ADDENDUM NO. 1

CSP# 207702

**Org # 194 – K.B. Polk Center for Academically Talented & Gifted -
Renovation**

20 December 2024

SHEET NUMBER
E6.04

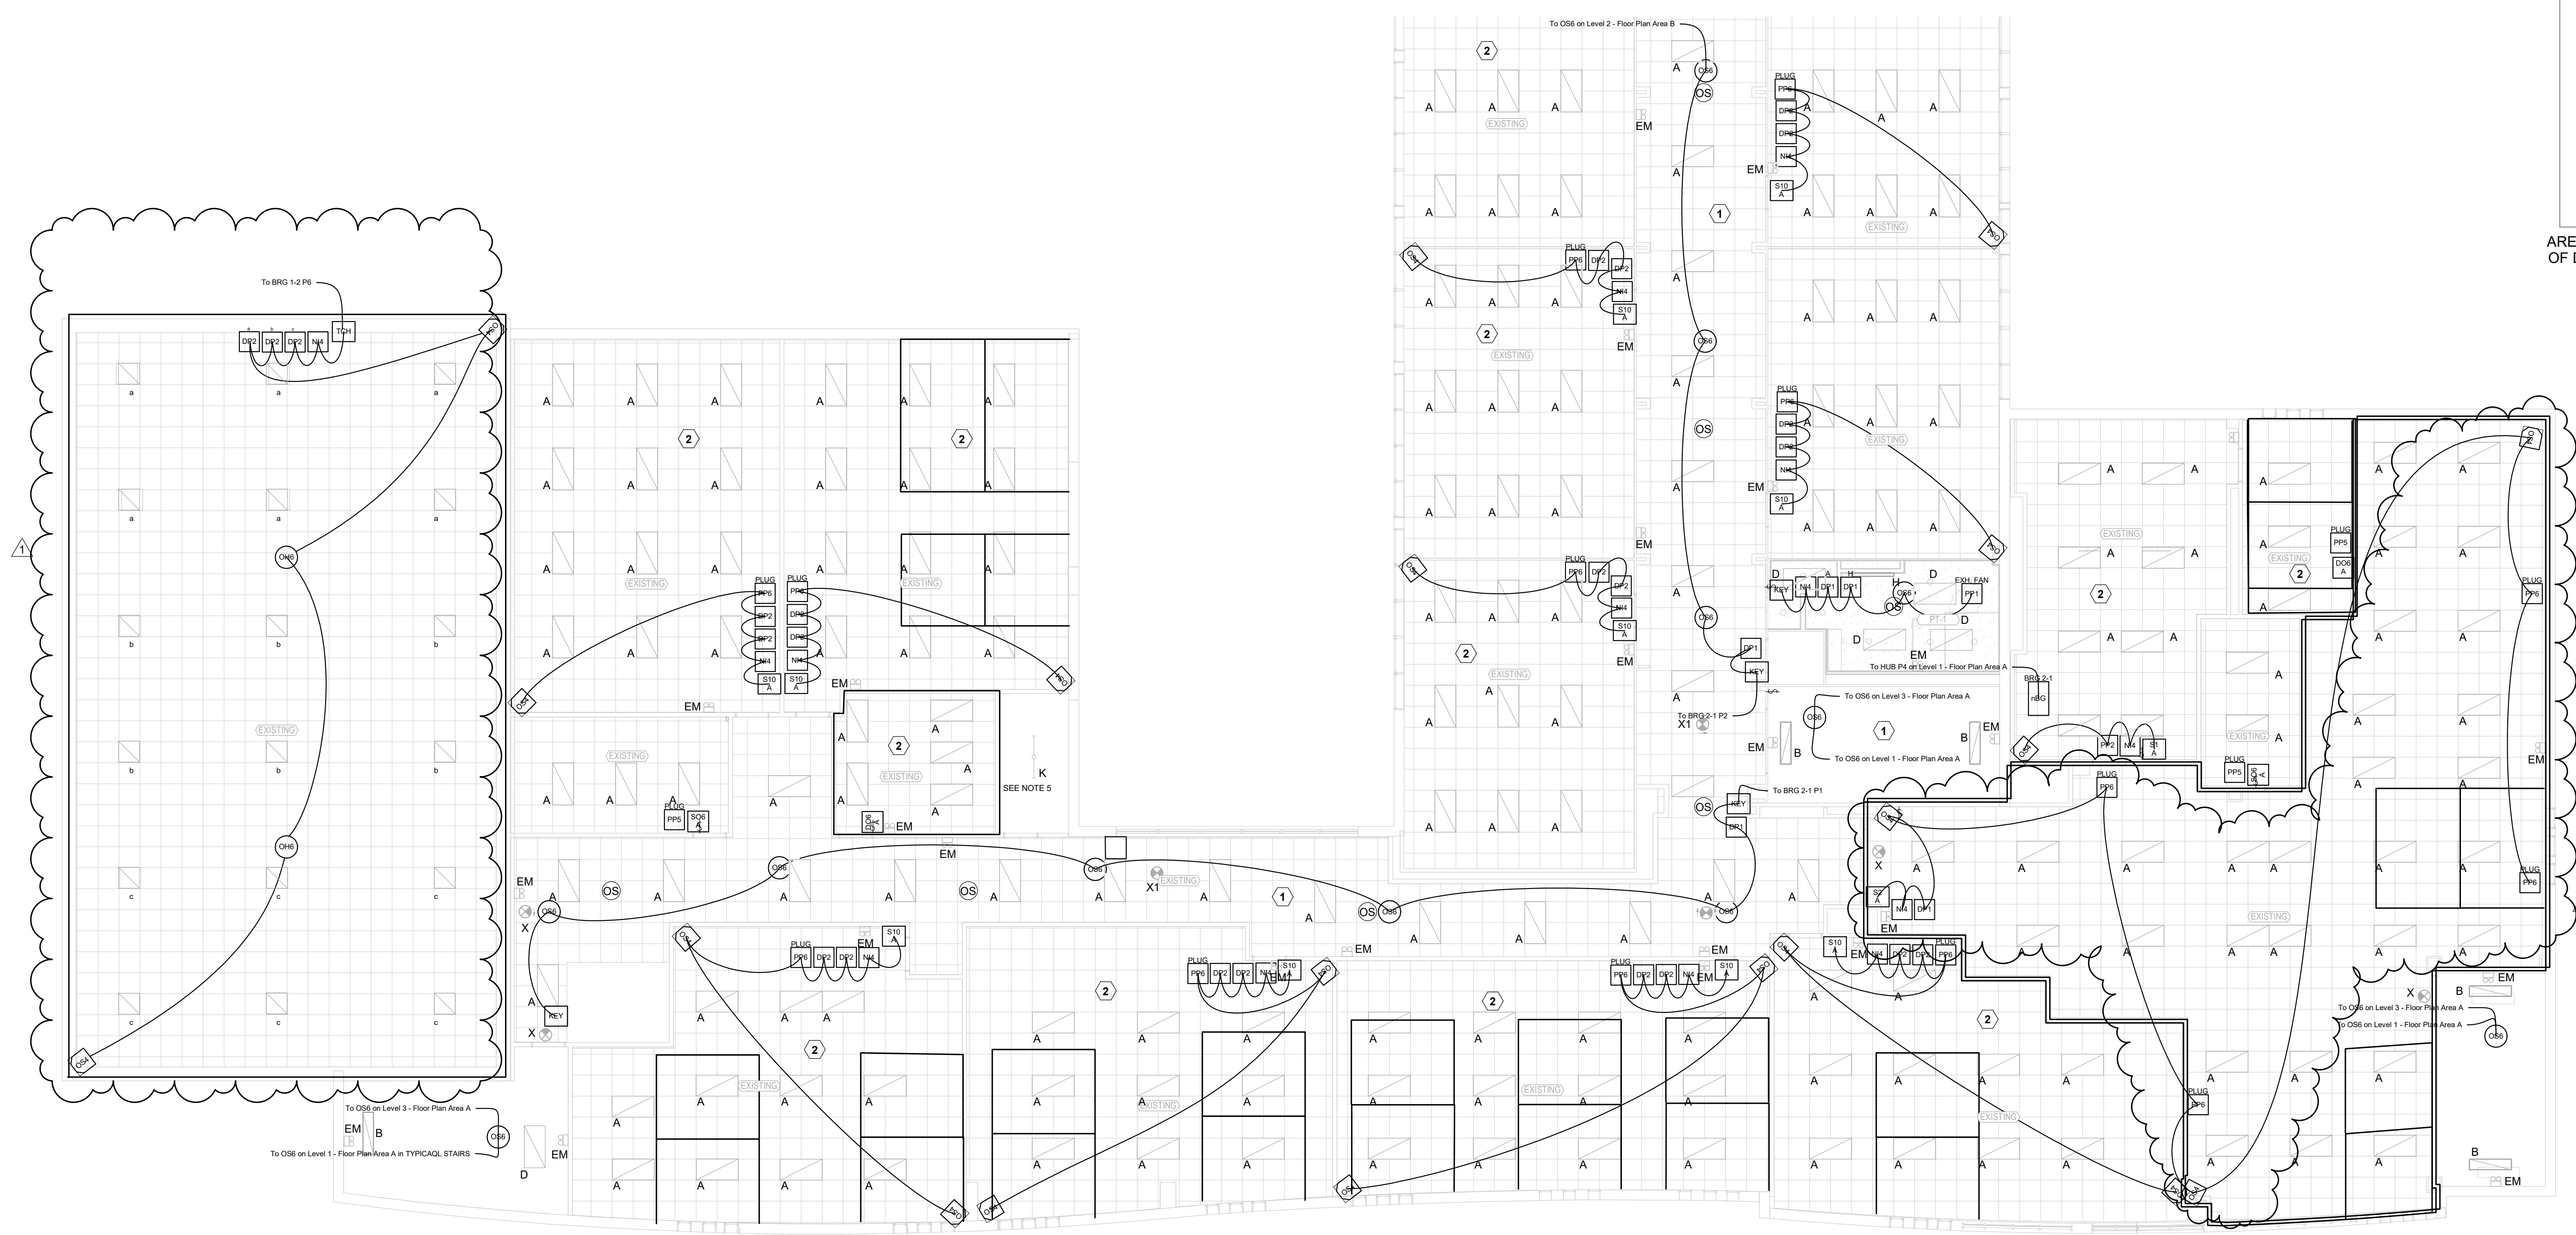
- Revised sheet notes and scope per attached sheet.
- **Sheet E6.04 – Replace sheet with the revised attached E6.04 LEVEL 2 LIGHTING CONTROLS PLAN A**
 - Revised sheet notes and scope per attached sheet.

SHEET NUMBER
E6.05

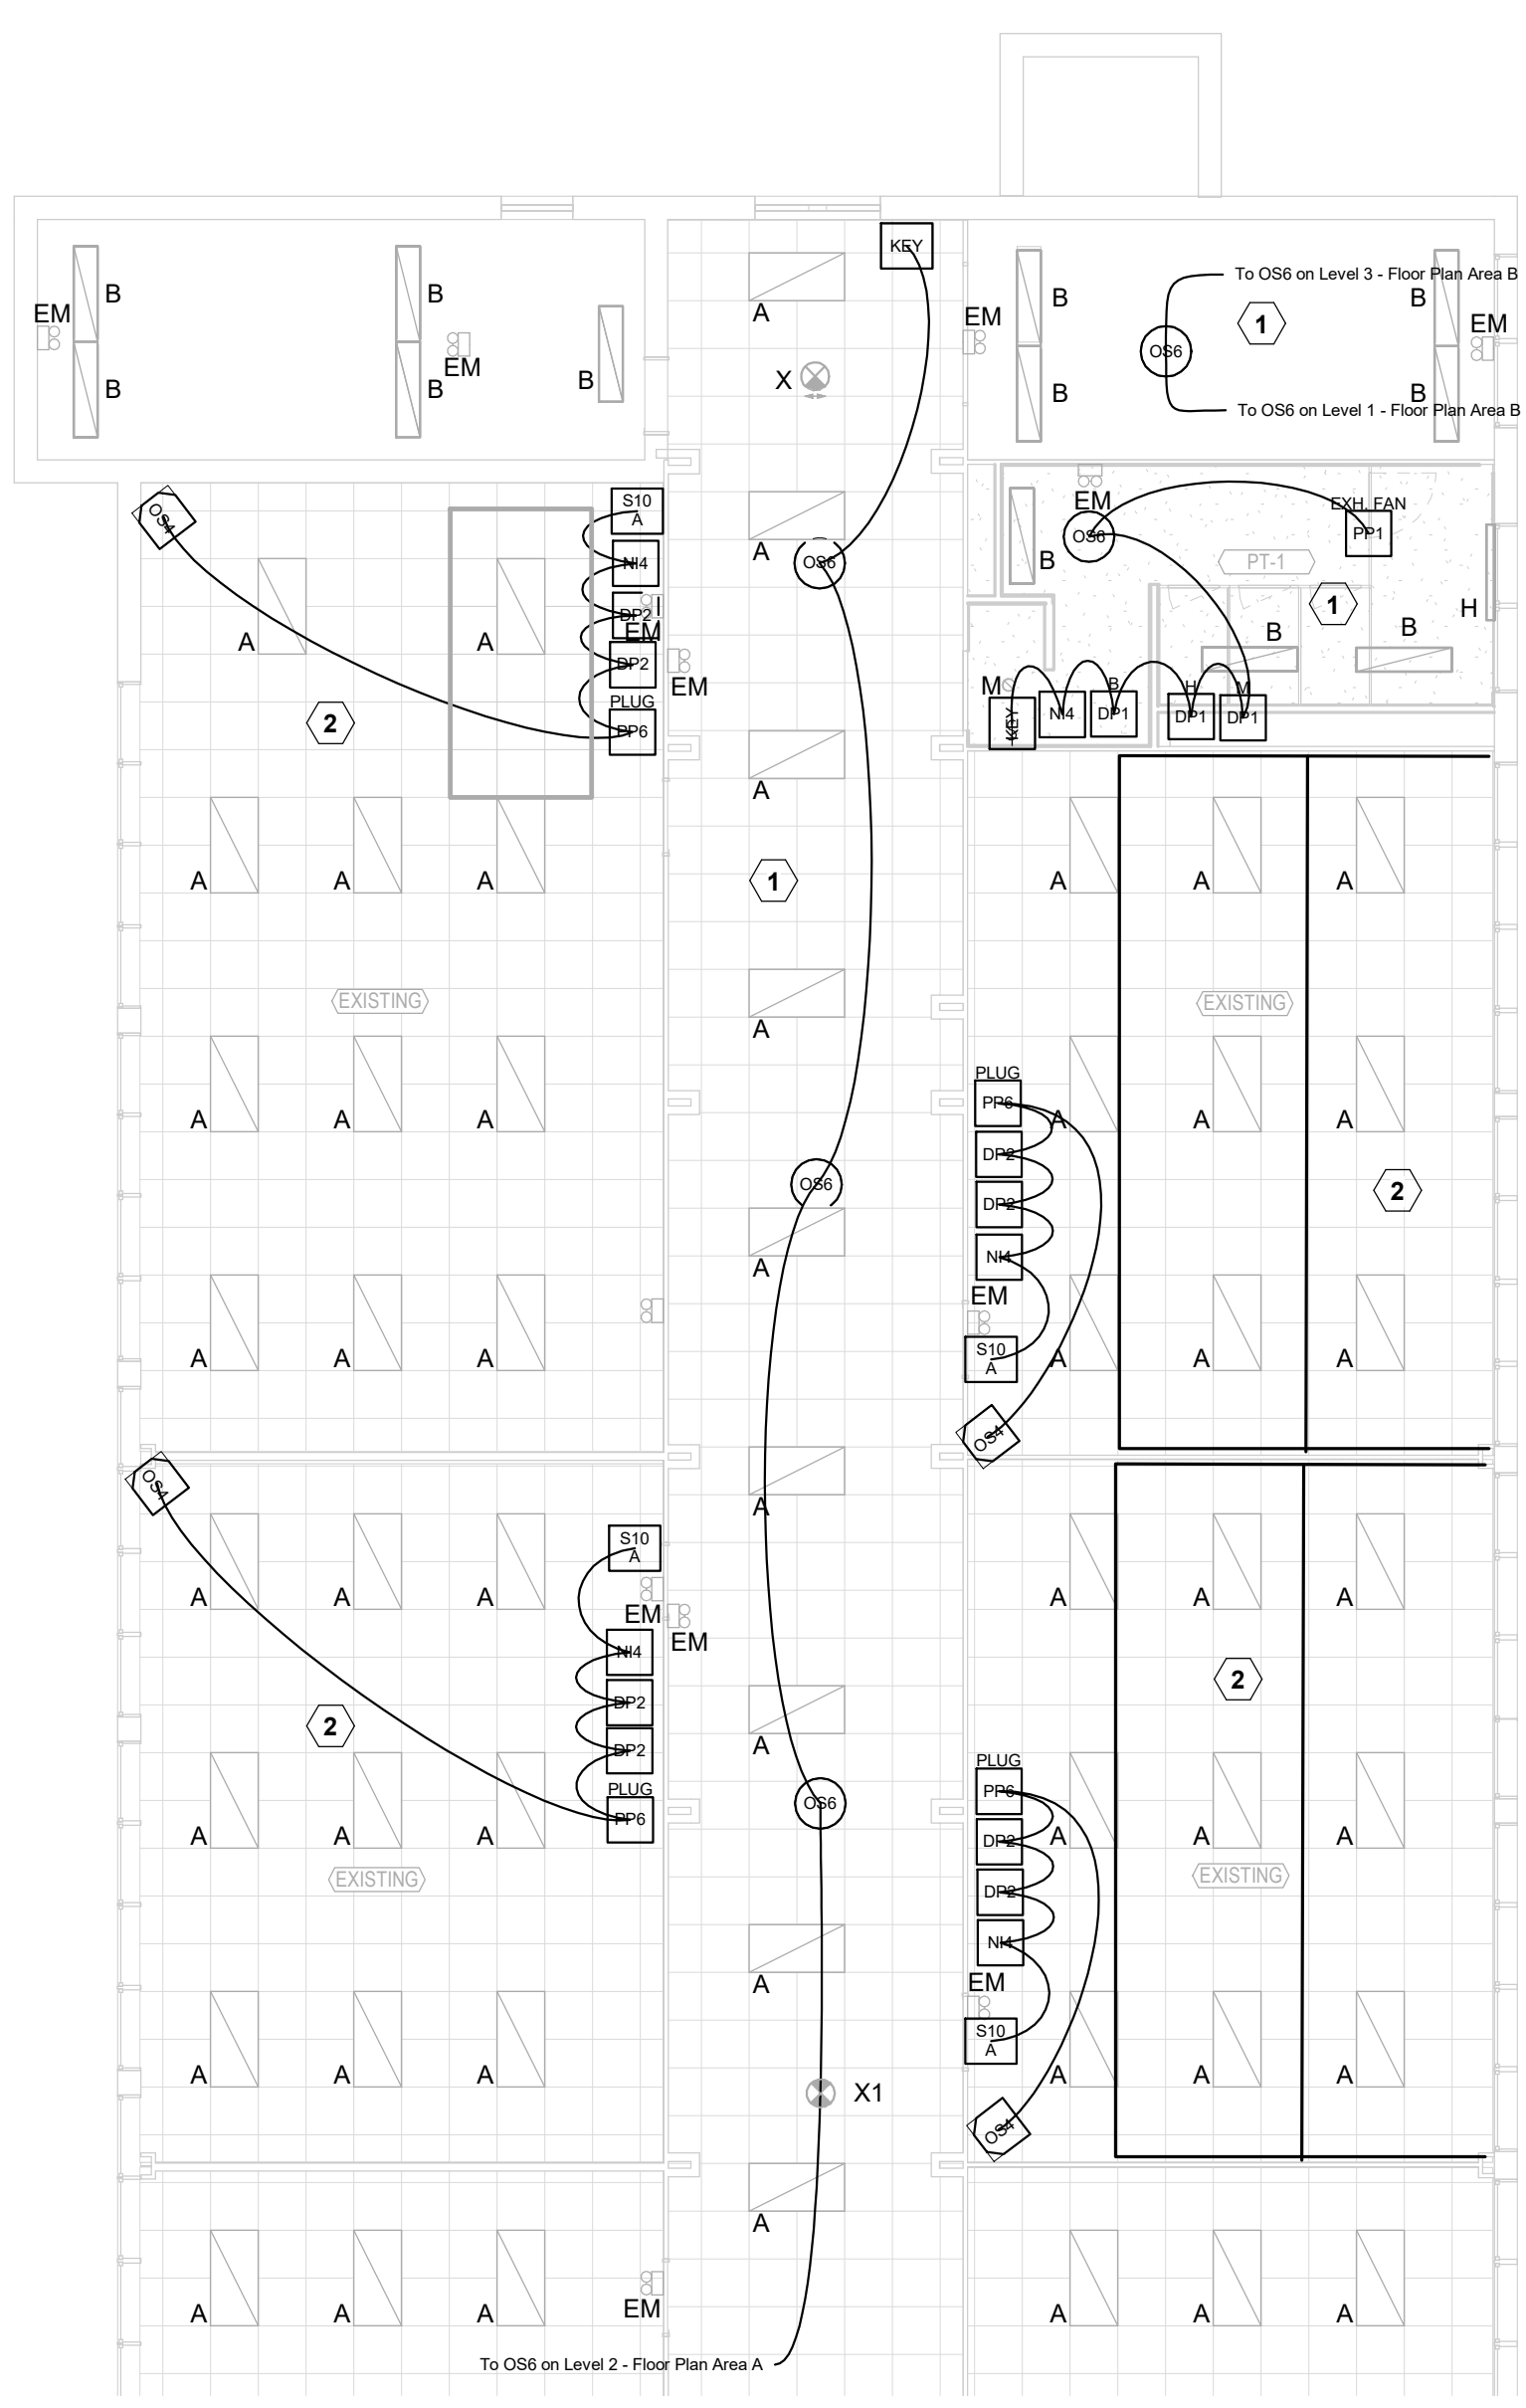
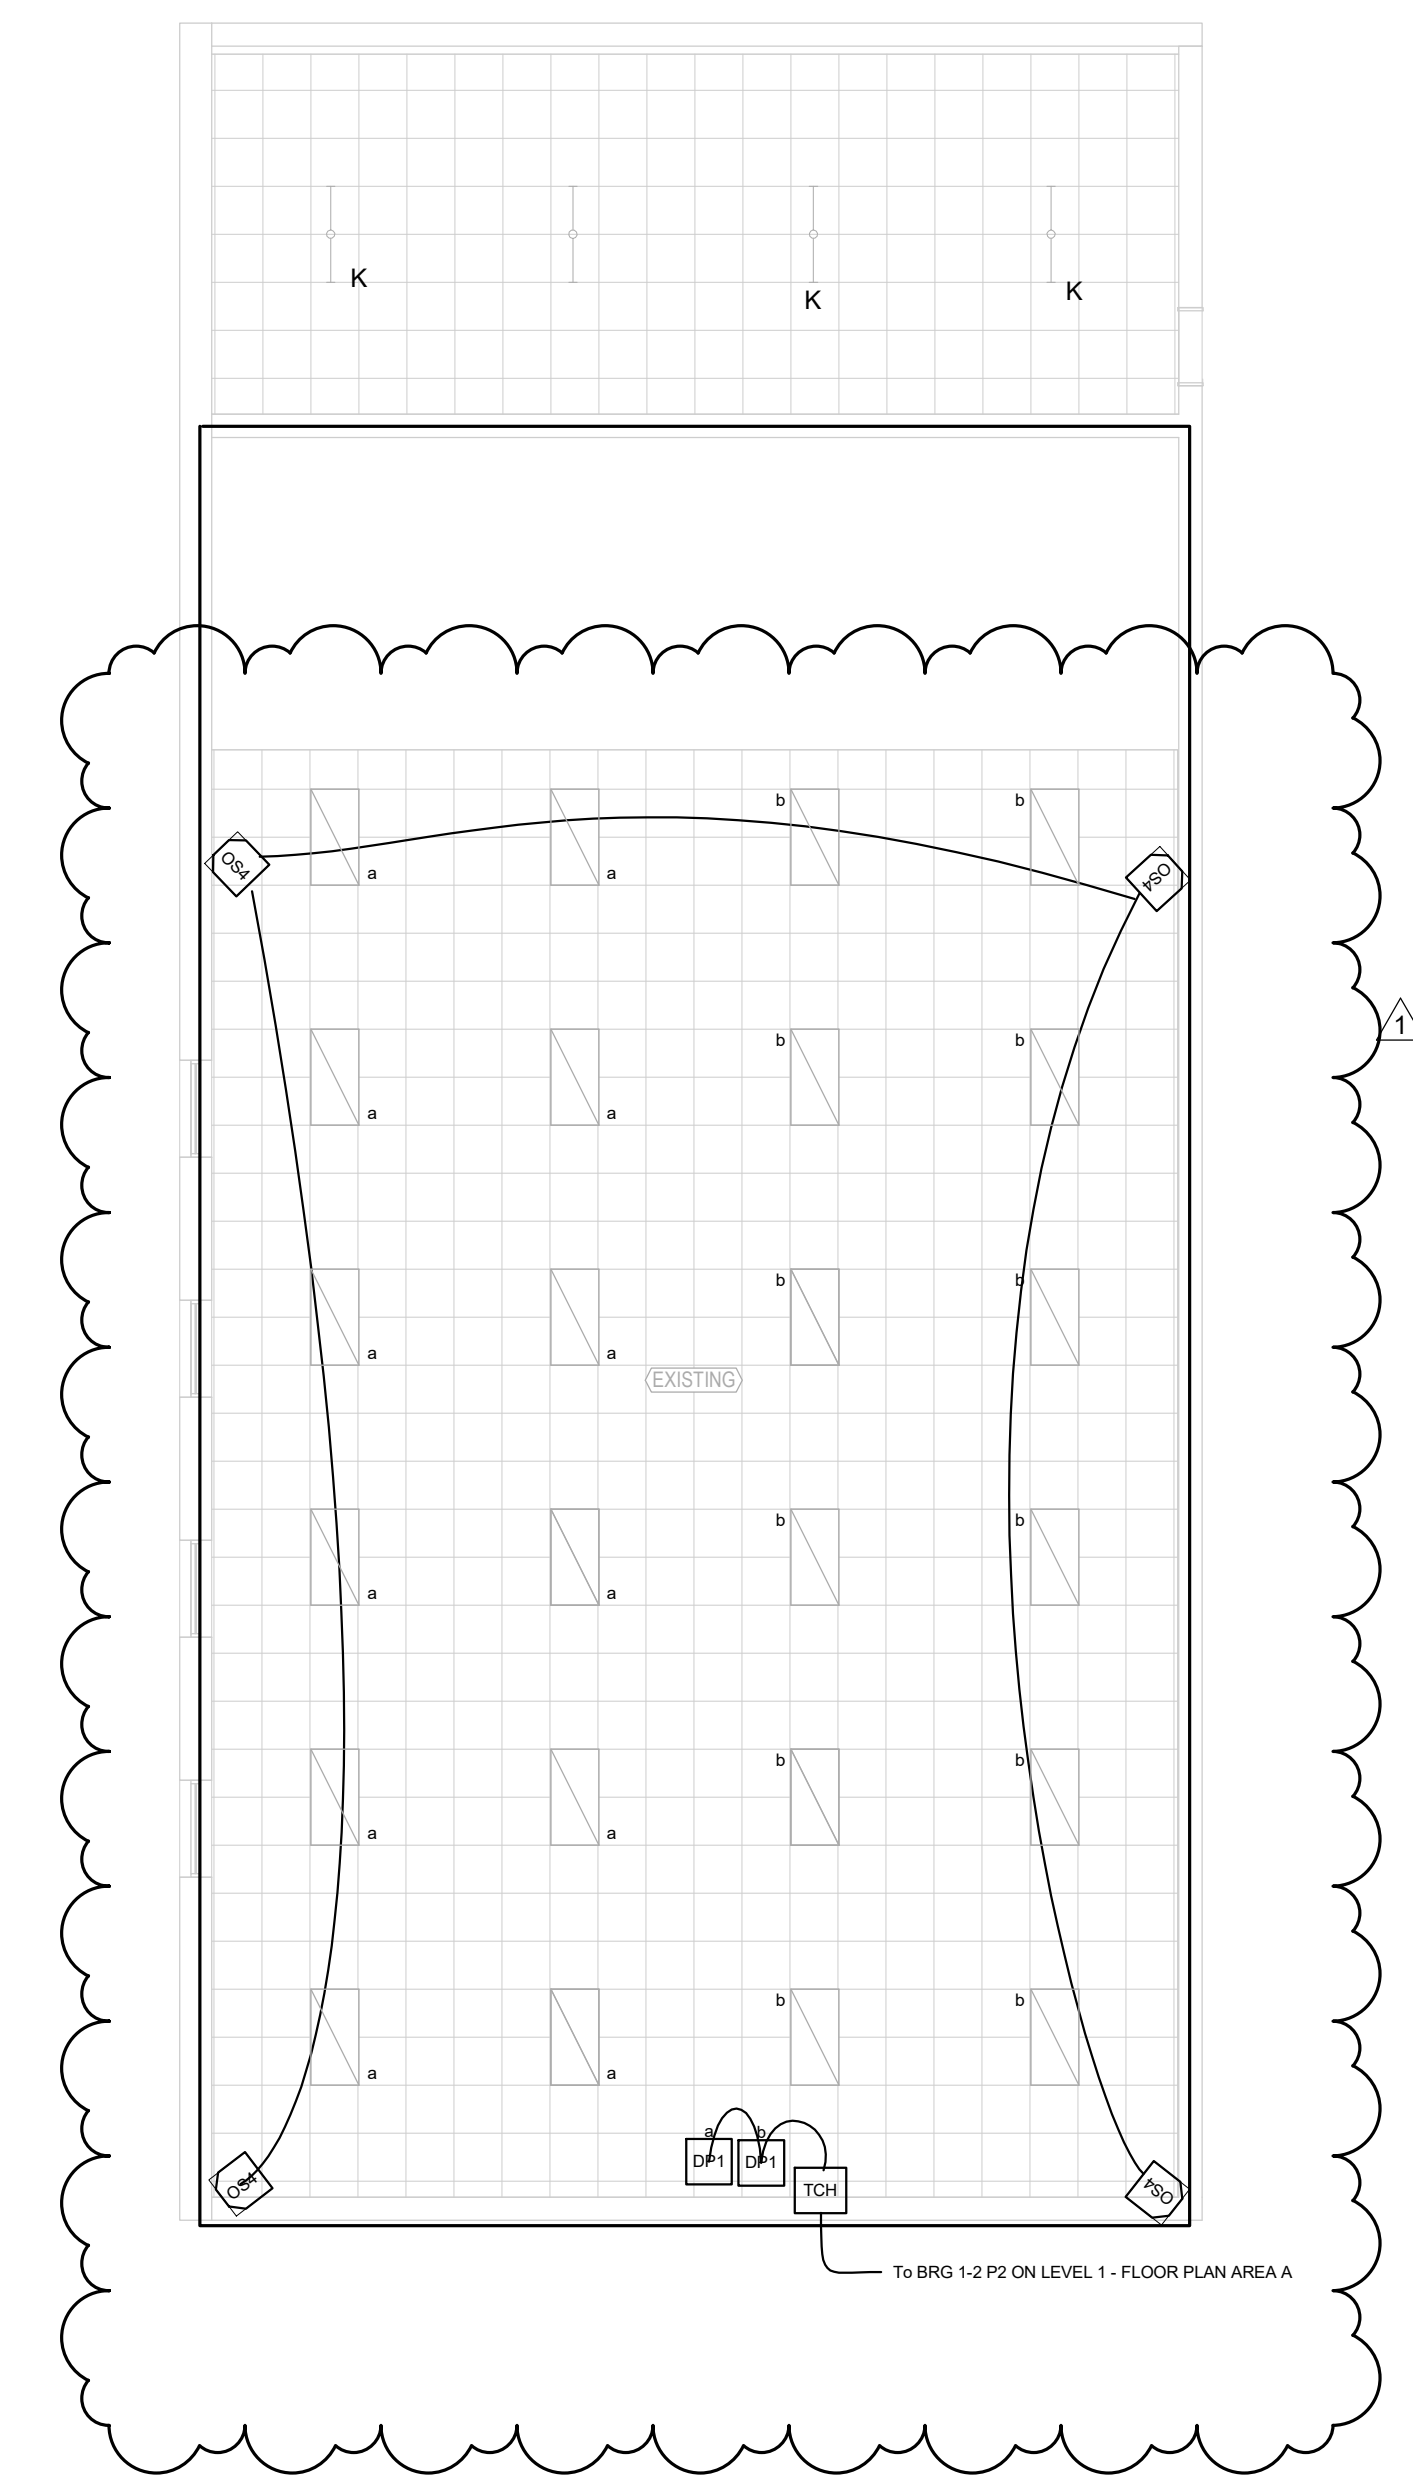
- **Sheet E6.05 - Replace sheet with the revised attached E6.05 LEVEL 2 LIGHTING CONTROLS PLAN B**
 - Revised sheet notes and scope per attached sheet.
- **Sheet E10.02 – Replace sheet with the revised attached E10.2 LIGHTING CONTROLS DETAILS**
